SERVICE BULLETIN

N° 139-678

DATE: July 5, 2022

ATA 53 – MIDDLE PANEL RETROMOD INSTALLATION

Figure 7

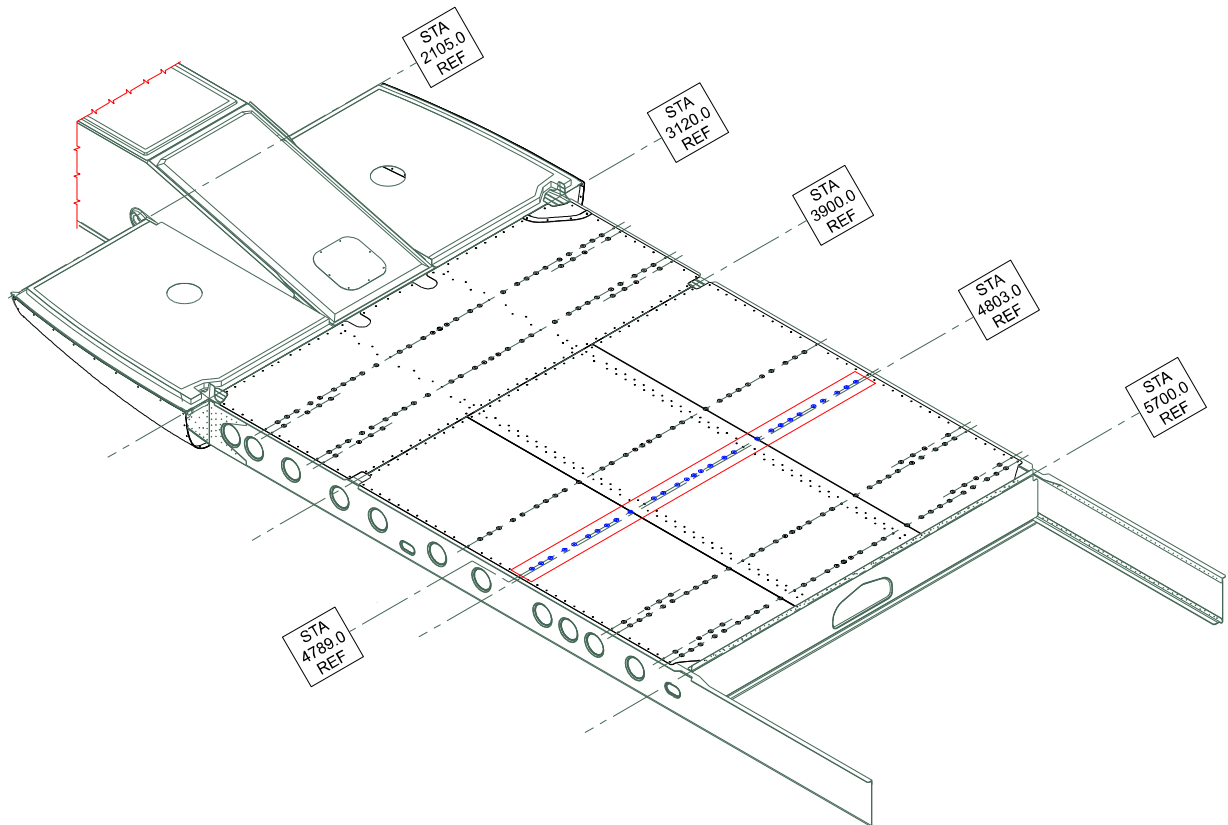
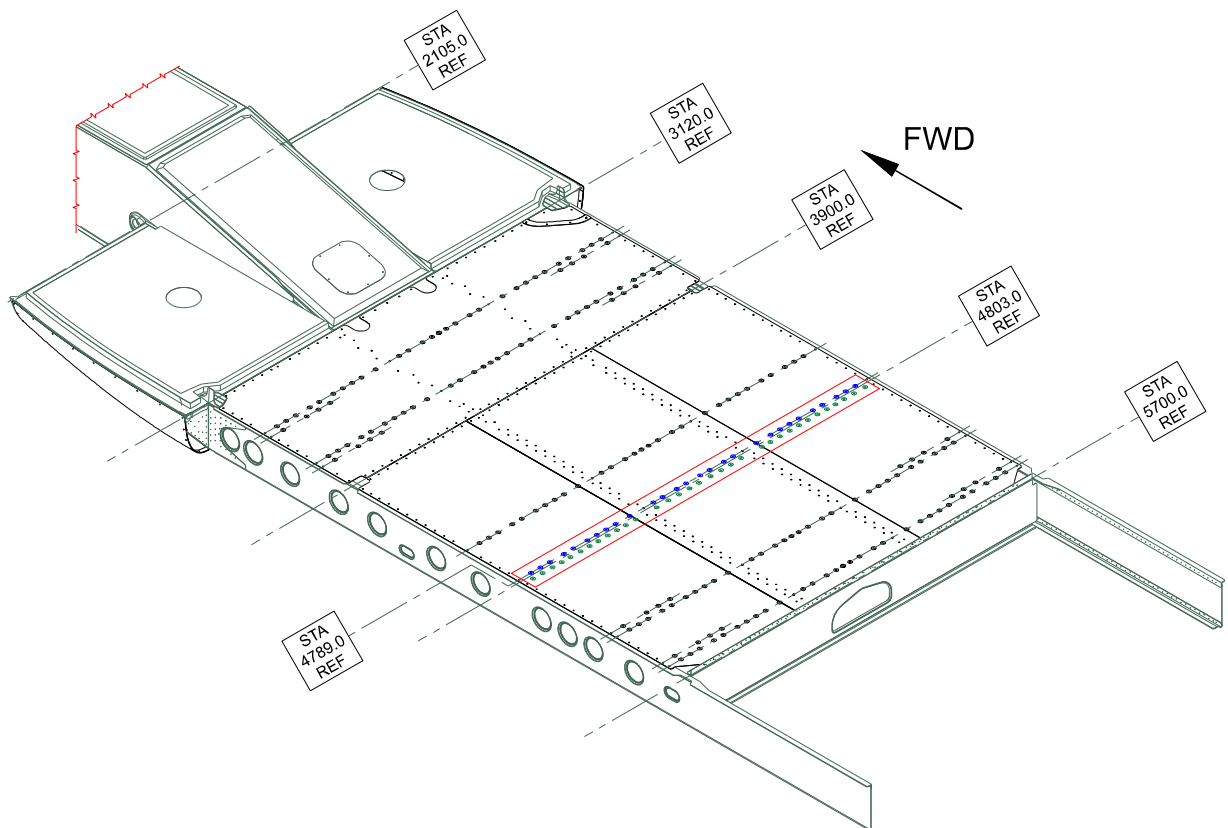
Affected seats configurations are shown in Figures 1 thru 6. The number of passenger cabin floor panels can be identified through the number of rivets rows at STA 4803 as shown in Figure 7:

- n°1 rivets row identifies a TWO panels floor;
- n°2 rivets rows identify a THREE panels floor.

Figure 8

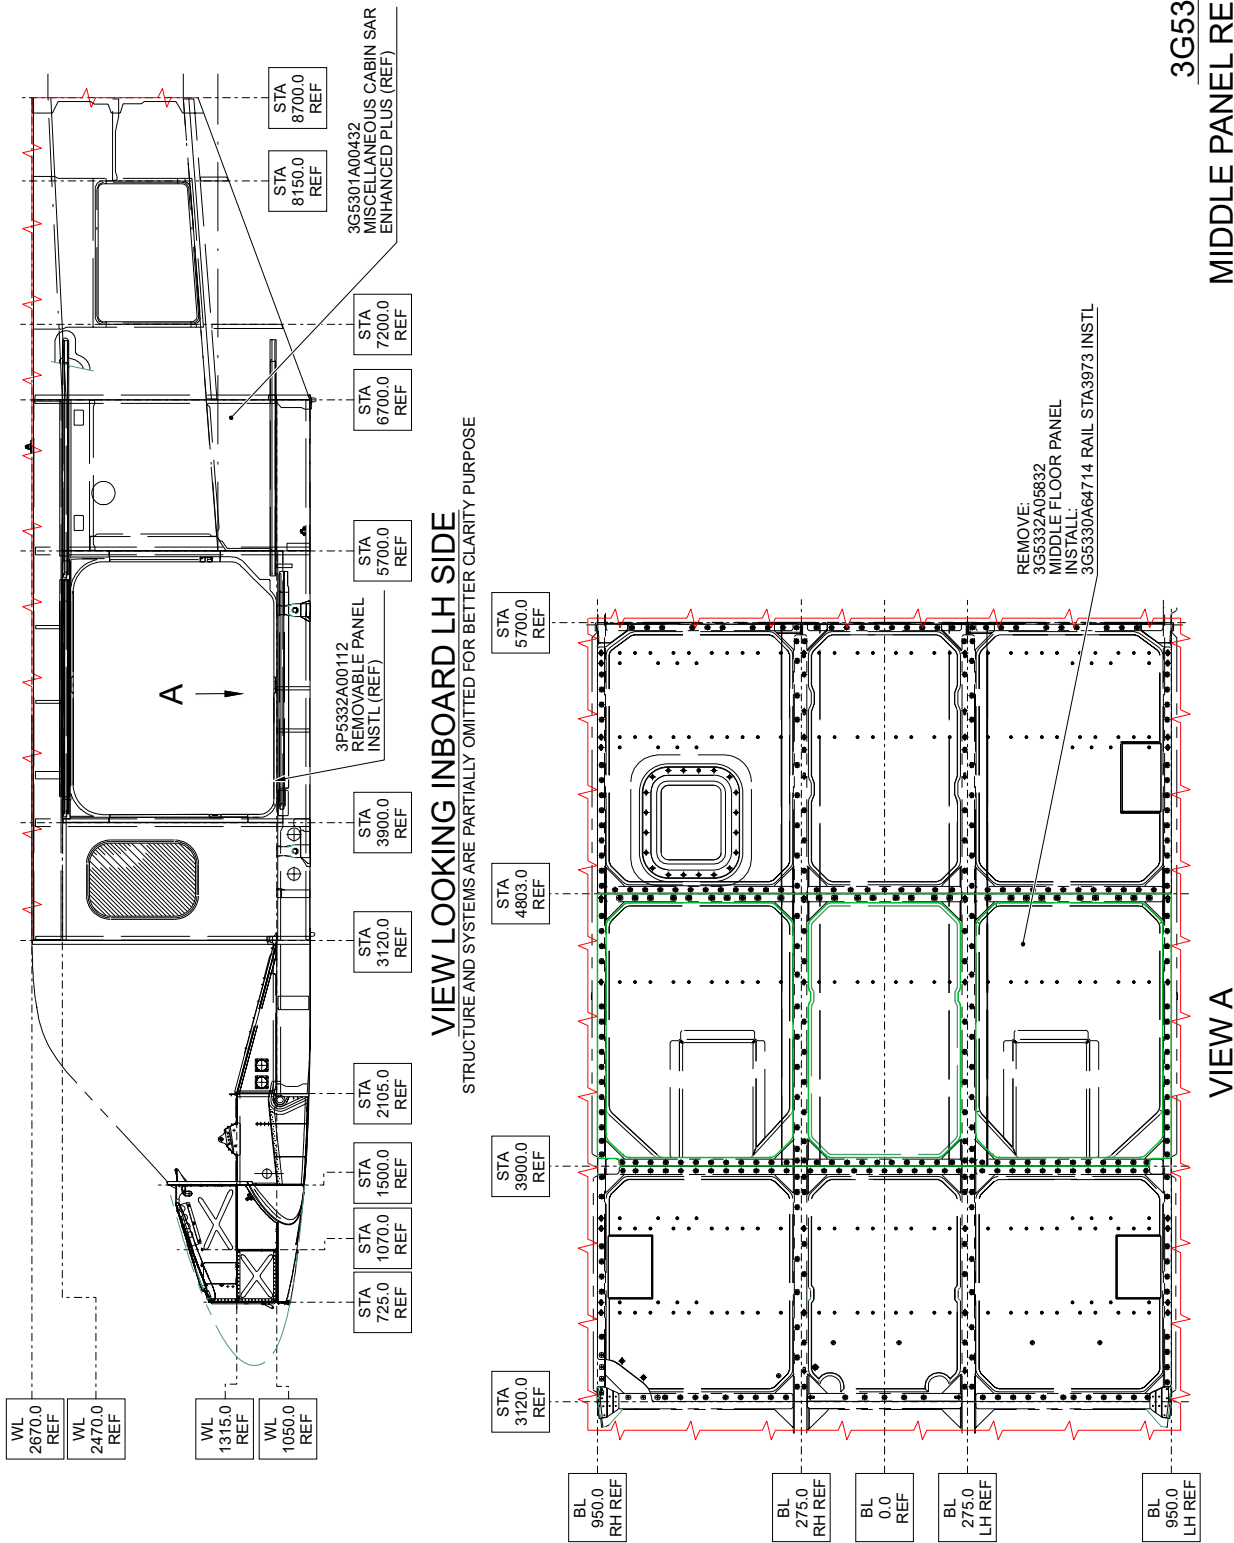
4. With reference to Figures 8, 12, 13 and 16, perform the retromod P/N 3G5332P01311 as described in the following procedure:
 - 4.1 With reference to Figure 8 View A and Figure 12 View A, remove the screws P/N MS27039-4-10, the screws P/N MS27039-4-10, the washers P/N NAS1149D0416K and the middle floor panel P/N 3G5332A05832 from the cabin structure.

Figure 9

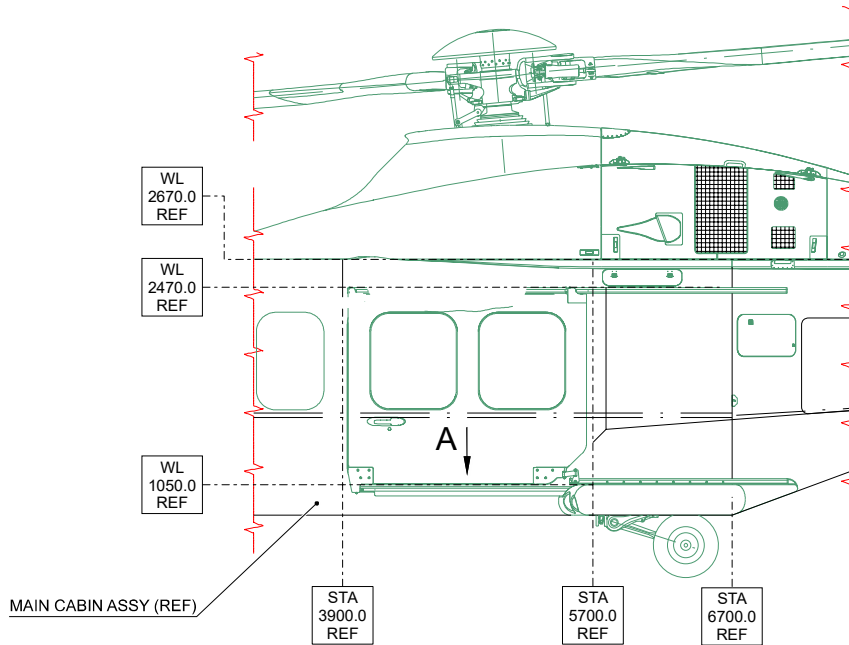
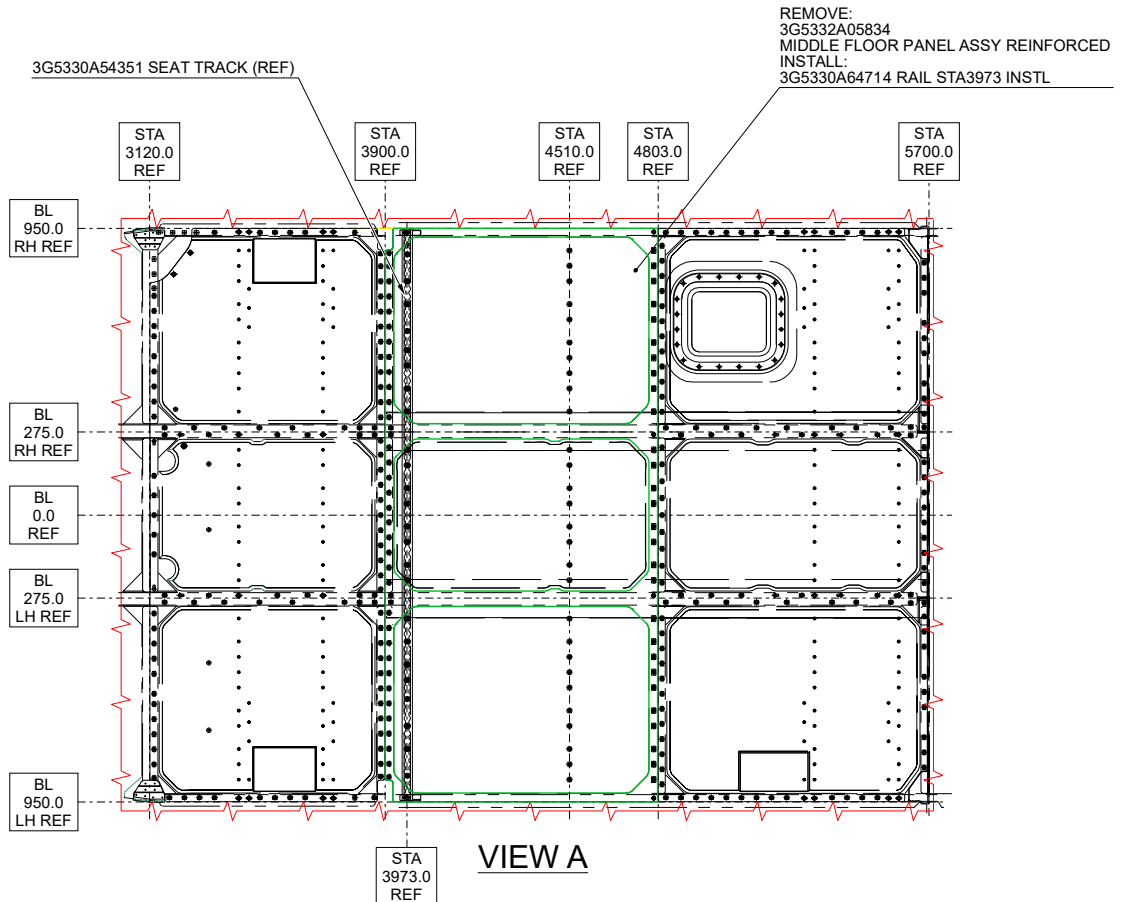
5. With reference to Figures 9, 12, 13 and 16 perform the retromod P/N 3G5332P01411 as described in the following procedure:
 - 5.1 With reference to Figure 9 View A and Figure 12 View A, remove the screws P/N MS27039-4-10, the screws P/N MS27039-4-10, the washers P/N NAS1149D0416K and the middle floor panel P/N 3G5332A05834 from the cabin structure.
 - 5.2 Perform steps from 4.2 thru 4.12.
6. In accordance with AMP Section 25 applicable DM, reinstall the 1st row central seat/seats previously removed.
7. In accordance with weight and balance changes, update the Chart A (see Rotorcraft Flight Manual, Part II, section 6).
8. Return the helicopter to flight configuration and record for compliance with Part II of this Service Bulletin on the helicopter logbook.
9. Send the attached compliance form to the following mail box:

Figure 10

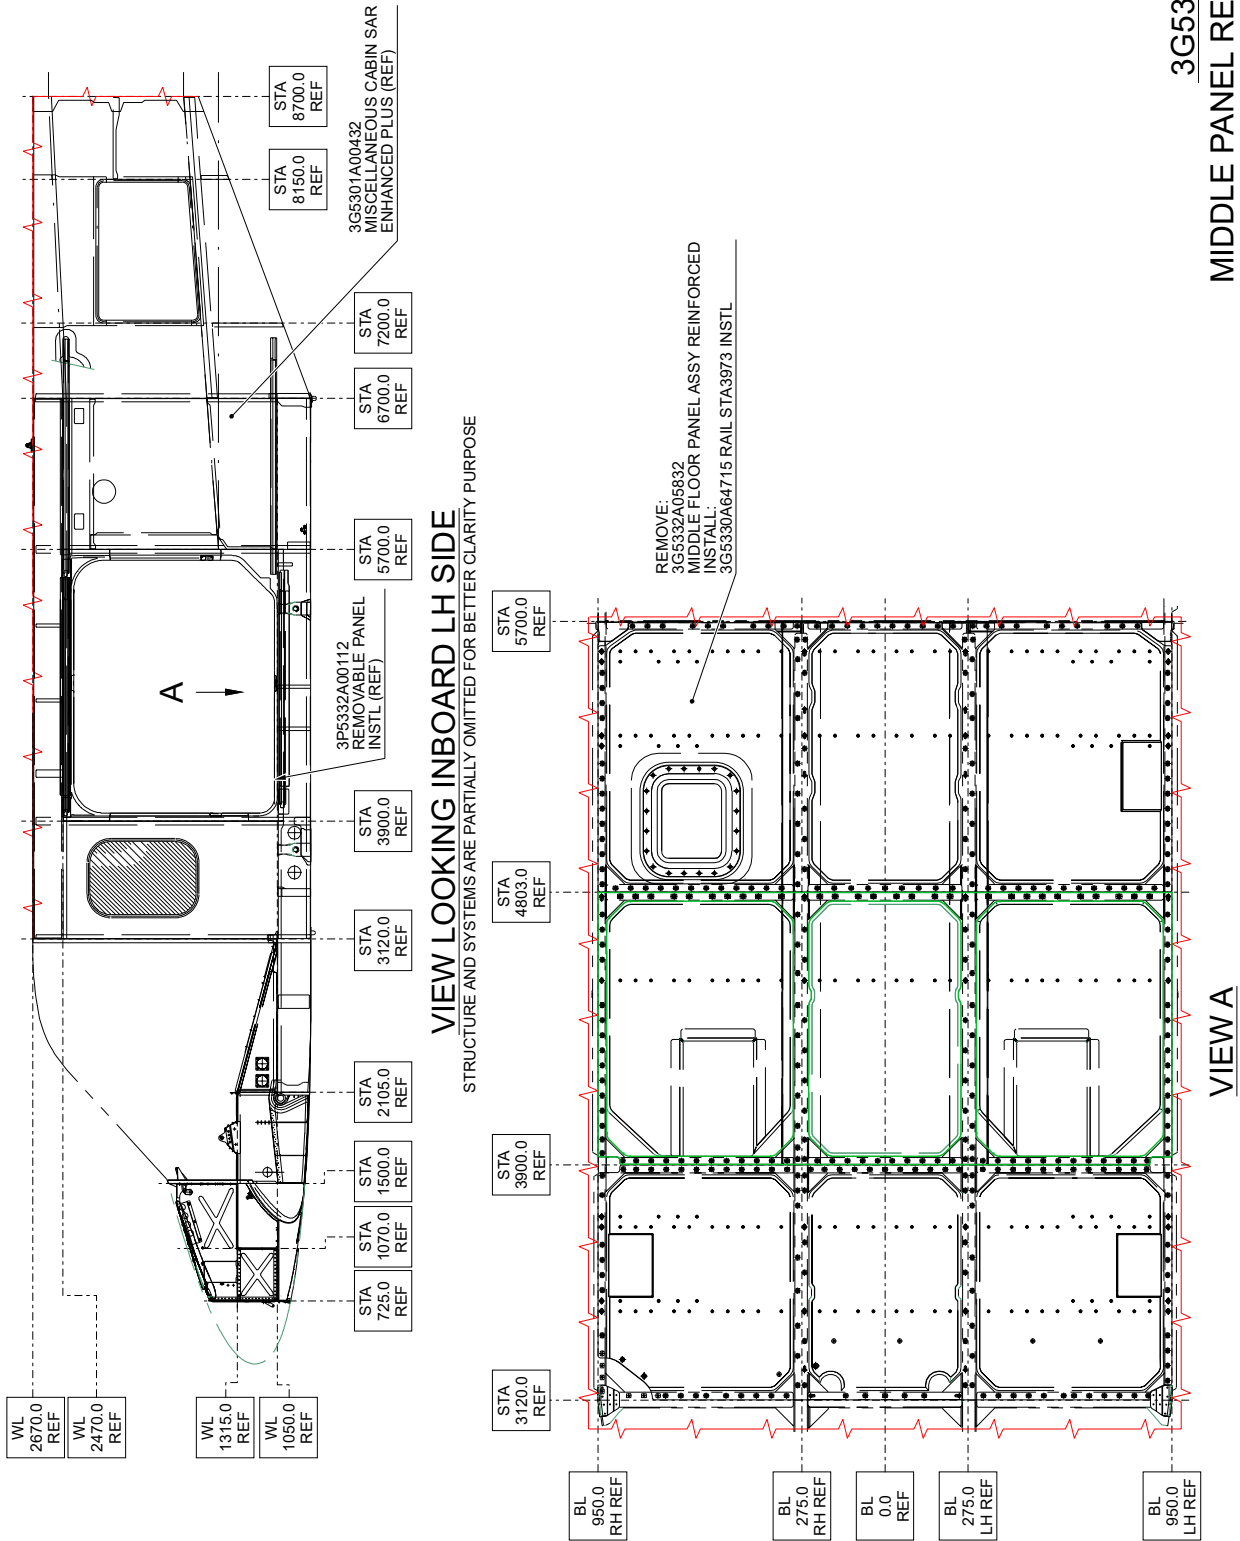
4. With reference to Figures 10, 14, 15 and 16, perform the retromod P/N 3G5332P01511 as described in the following procedure:
 - 4.1 With reference to Figure 10 View A and Figure 14 View A, remove the screws P/N MS27039-4-10, the screws P/N MS27039-4-10, the washers P/N NAS1149D0416K and the middle floor panel P/N 3G5332A05832 from the cabin structure.

Figure 11

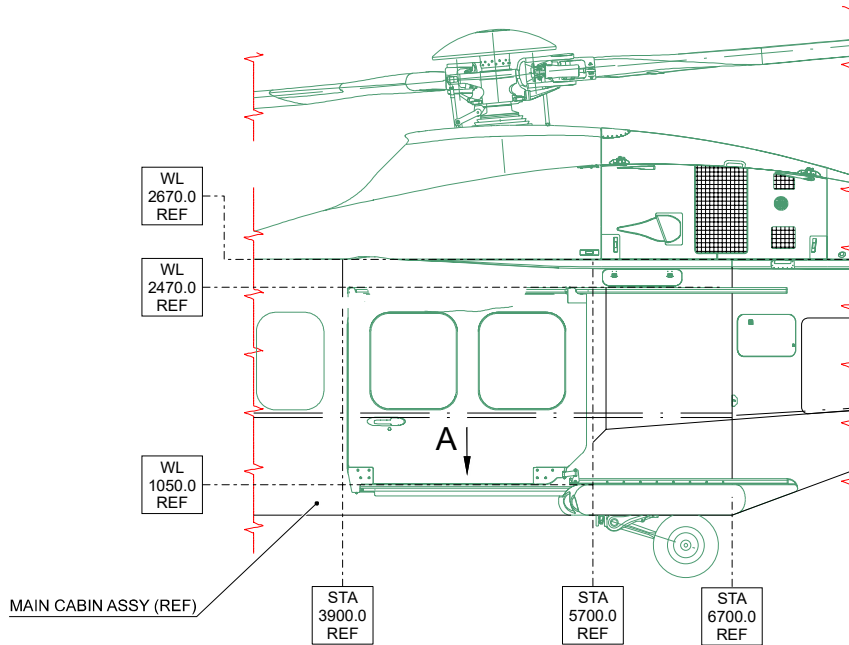
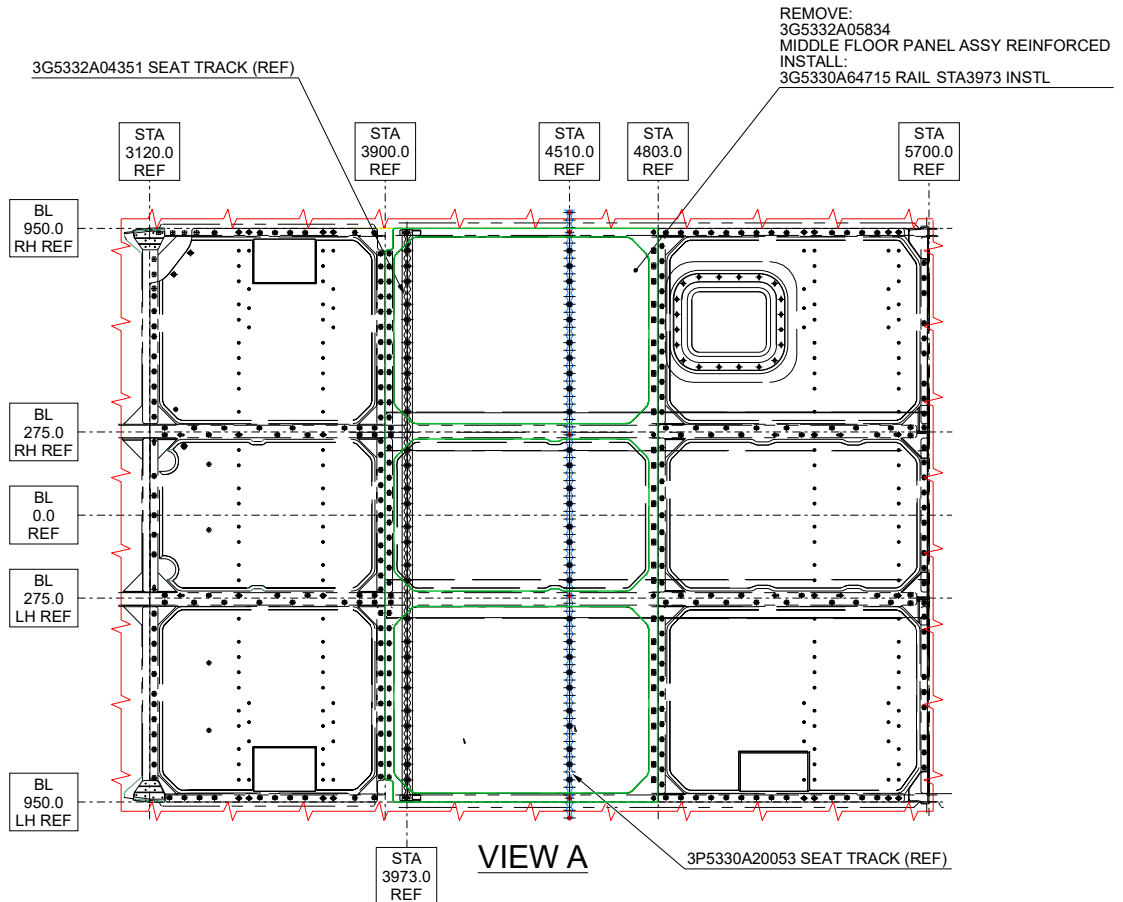
5. With reference to Figures 11, 14, 15 and 16 perform the retromod P/N 3G5332P01611 as described in the following procedure:
 - 5.1 With reference to Figure 11 View A, remove the middle floor panel P/N 3G5332A05834 from the cabin structure.
 - 5.2 Perform from step 4.2 thru step 4.12.
6. In accordance with AMP Section 25 applicable DM, reinstall the 1st row central seat/seats previously removed.
7. In accordance with weight and balance changes, update the Chart A (see Rotorcraft Flight Manual, Part II, section 6).
8. Return the helicopter to flight configuration and record for compliance with Part III of this Service Bulletin on the helicopter logbook.
9. Send the attached compliance form to the following mail box:
